Company	Trenz Electronic GmbH
PCN Number	PCN-20190108
Title	TE0807-02-* SPI Flash Change
Subject	BOM change
Issue Date	2019-07-08

### #1 Change SPI Flash from N25Q512A11G1240E to MT25QU512ABB8E12-0SIT

Locate Flash (U7, U17) on bottom side of PCB:

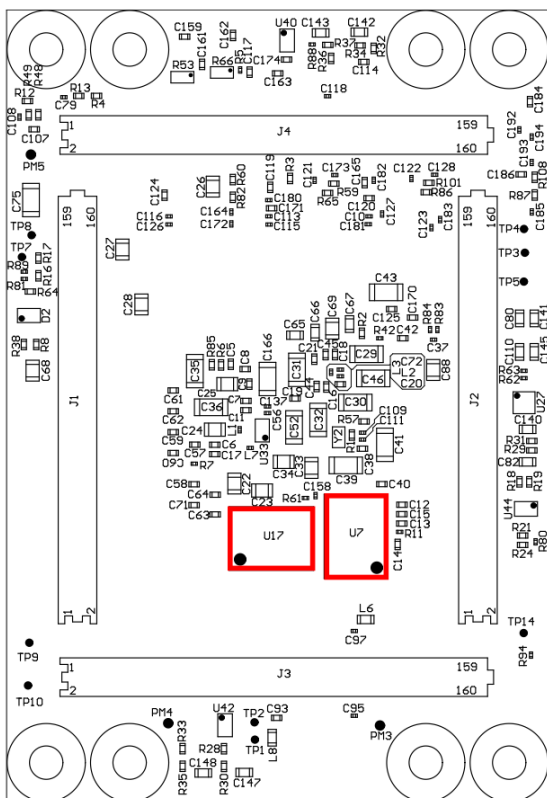
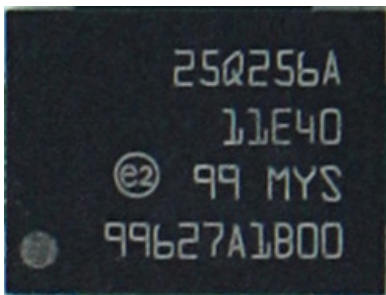
**Reason:** N25Q512A11G1240E became obsolete.

**Impact:** None. Both have same JEDEC ID BB20h and manufacturer ID 20h.

old	new
<b>N25Q512A11G1240E</b>	<b>MT25QU512ABB8E12-0SIT</b>
